Freeth Farm, Compton Bassett, Temporary Diversion under TCPA1990, S.257 and 261

Rights of Way temporary diversion and reinstatement of existing routes

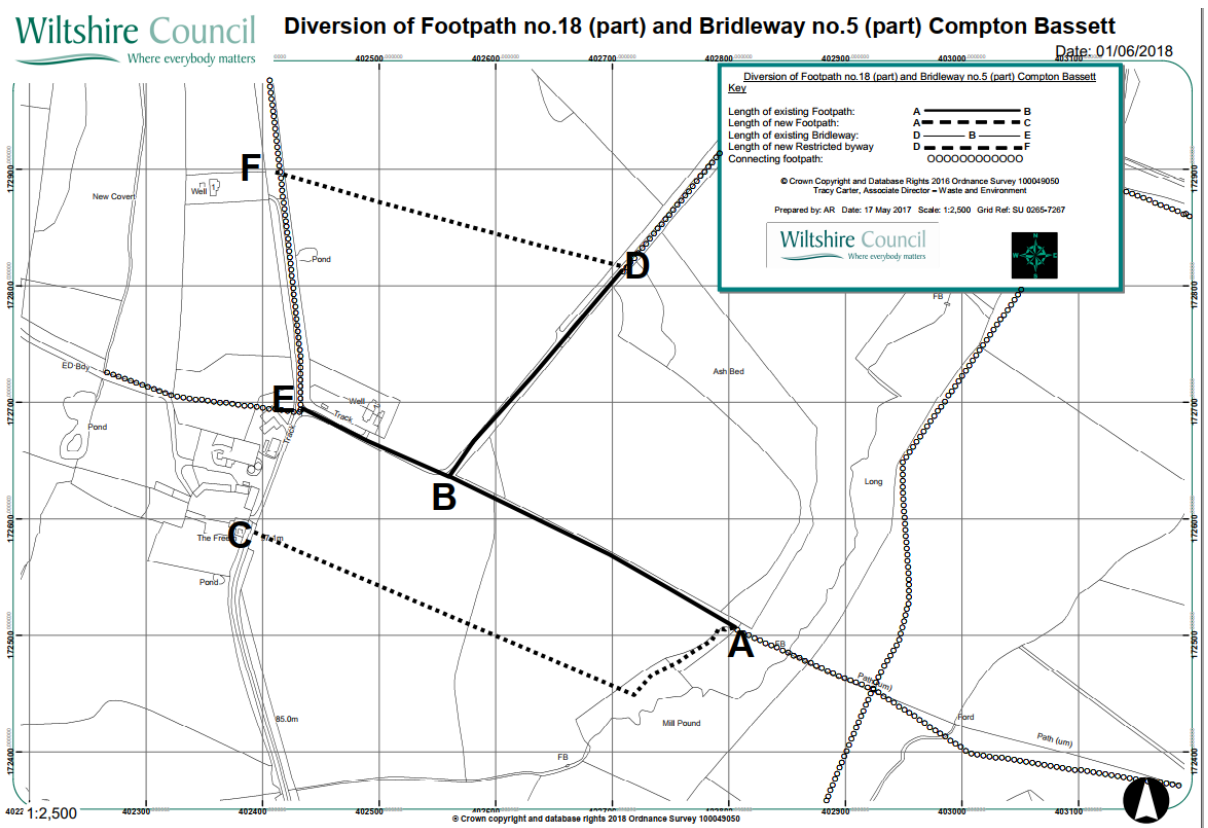
Path specification required for the new temporary restricted byway route D -F. The same construction could be used on the footpath A - C section

We will require the restricted byway D-F being a minimum of 6m usable width, but the surfaced section can be 4m wide.

Footpath section A-C shall be constructed with a minimum of 2m width

A twin wall 600mm diameter 6m long corrugated pipe with bagged headwalls will be provided at point F as required to link the temporary route to the existing network

A path tray will be cut to a depth of 350mm, and 4m wide D-F section and 2m for the footpath A-C section and materials removed from the path and surrounding area or stored within the site.

When the extraction of materials has taken place the original routes will be reinstated. As the Highway Authority we will only sign off the completion of these routes to our satisfaction. These routes Bridleway D-B-E will be reinstated to the same surface standard we have stipulated for the temporary routes (as above specification) as well as the footpath A-B

The usable widths will be as the original widths of between 6m for Bridleway D-B-E (4m width for surfacing)and minimum of 2m for the footpath A-B
